RE: Jennesstown Manor Site Plan Application
Tax Map 7, Lots 39 & 39-1 – Warner

Aries Engineering Review Comments, dated October 20, 2025

Summary for Pond 41P: Pocket Pond 41P

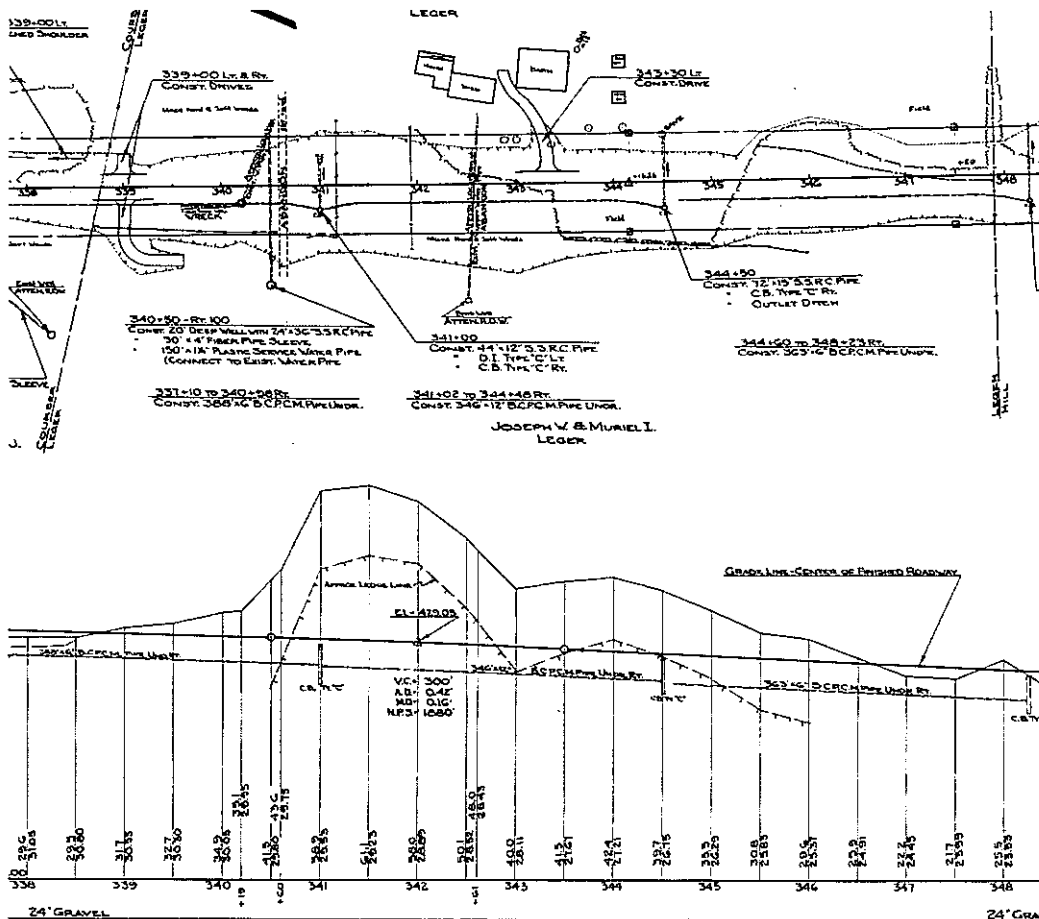
16. The presence of standing water within Pocket Pond #41 will reduce the intended storage capacity, which is not likely accounted for in the stormwater model flows.

Based on the administrative rules a pocket pond is required to maintain the standing water.

Below is a snapshot of Node 41P of the HydroCAD analysis. Storage capacity is adjusted by the use of a starting elevation. In the case of this pond the starting elevation is set at 440.10 to match the elevation of the lowest outlet (device 2). The total cumulative storage of the pond is 10,747 cf, but the flood elevation lists 5,215 cf above start.

The calculations properly address the storage capacity.
